Proposed Revisions to a Standard Plans Index

Originator:	Turley, Joshua	Index Number:	700-041
Date:	4/11/2024	Sheet Number(s):	2
E-mail:	Joshua.Turley@dot.state.fl.us	Index Title:	SPAN SIGN STRUCTURE

Sheet 2: Added labeling to the Anchor bolt nuts in BASE PLATE CONNECTION - ELEVATION

BASE PLATE CONNECTION

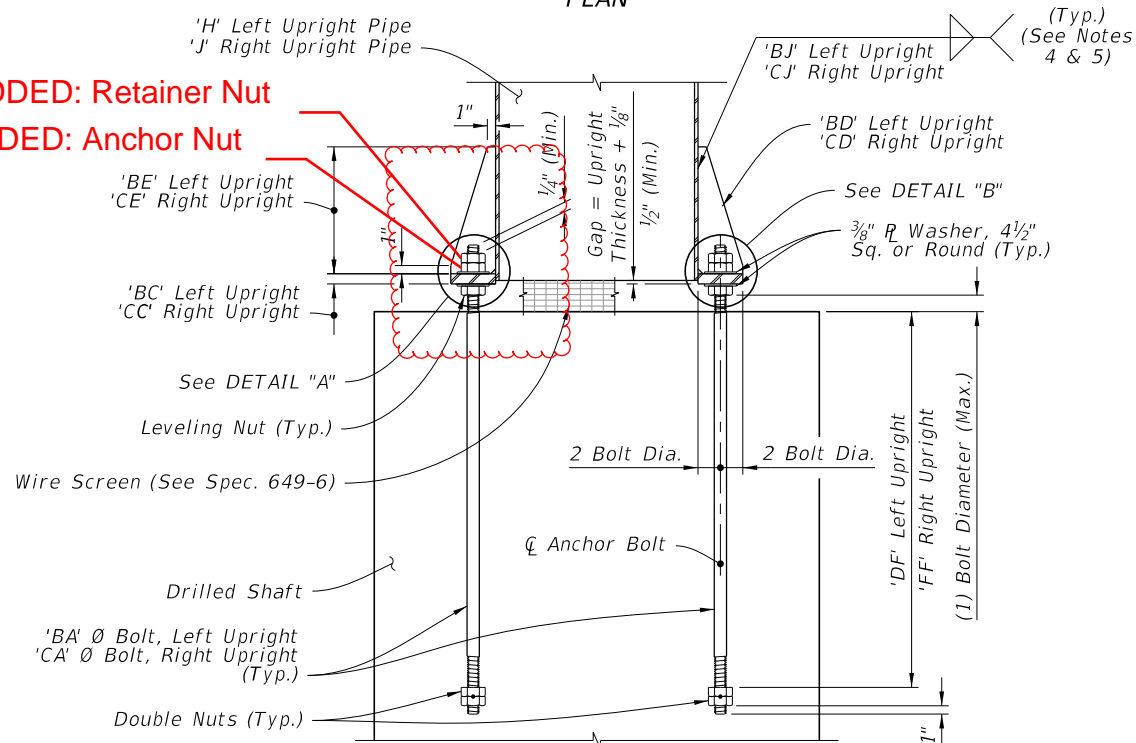
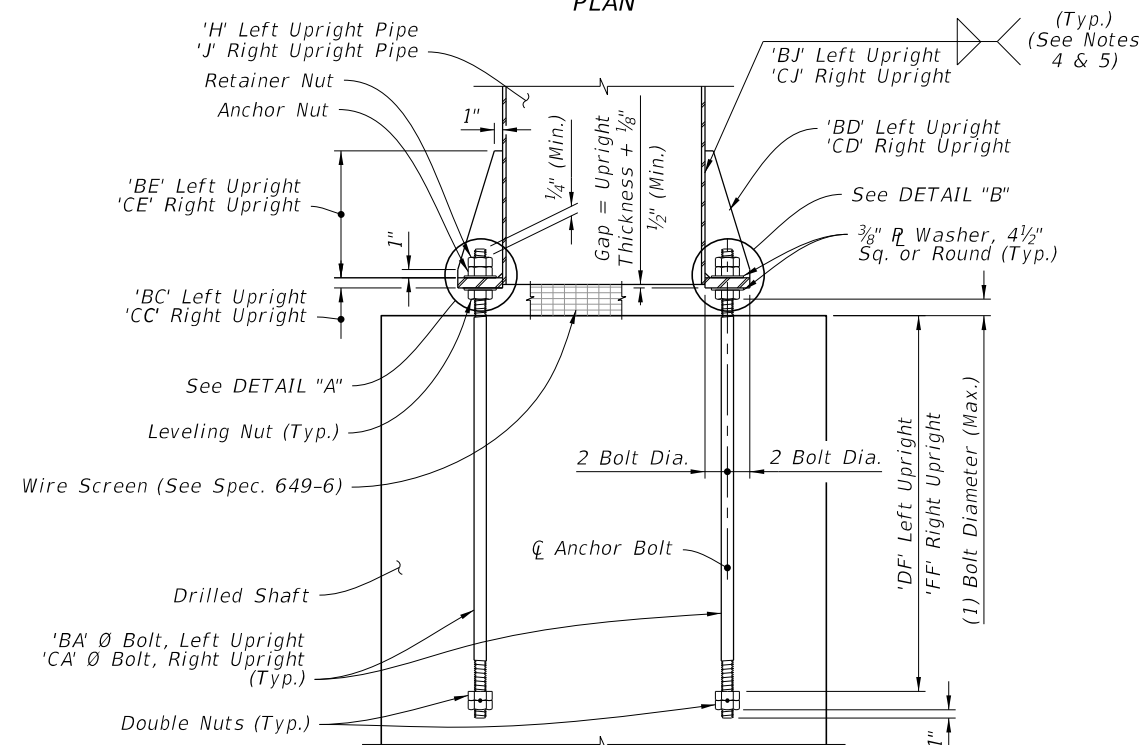
Labels were added to correspond correctly with upcoming spec change to Spec 649.

ADDED: Retainer Nut
ADDED: Anchor Nut
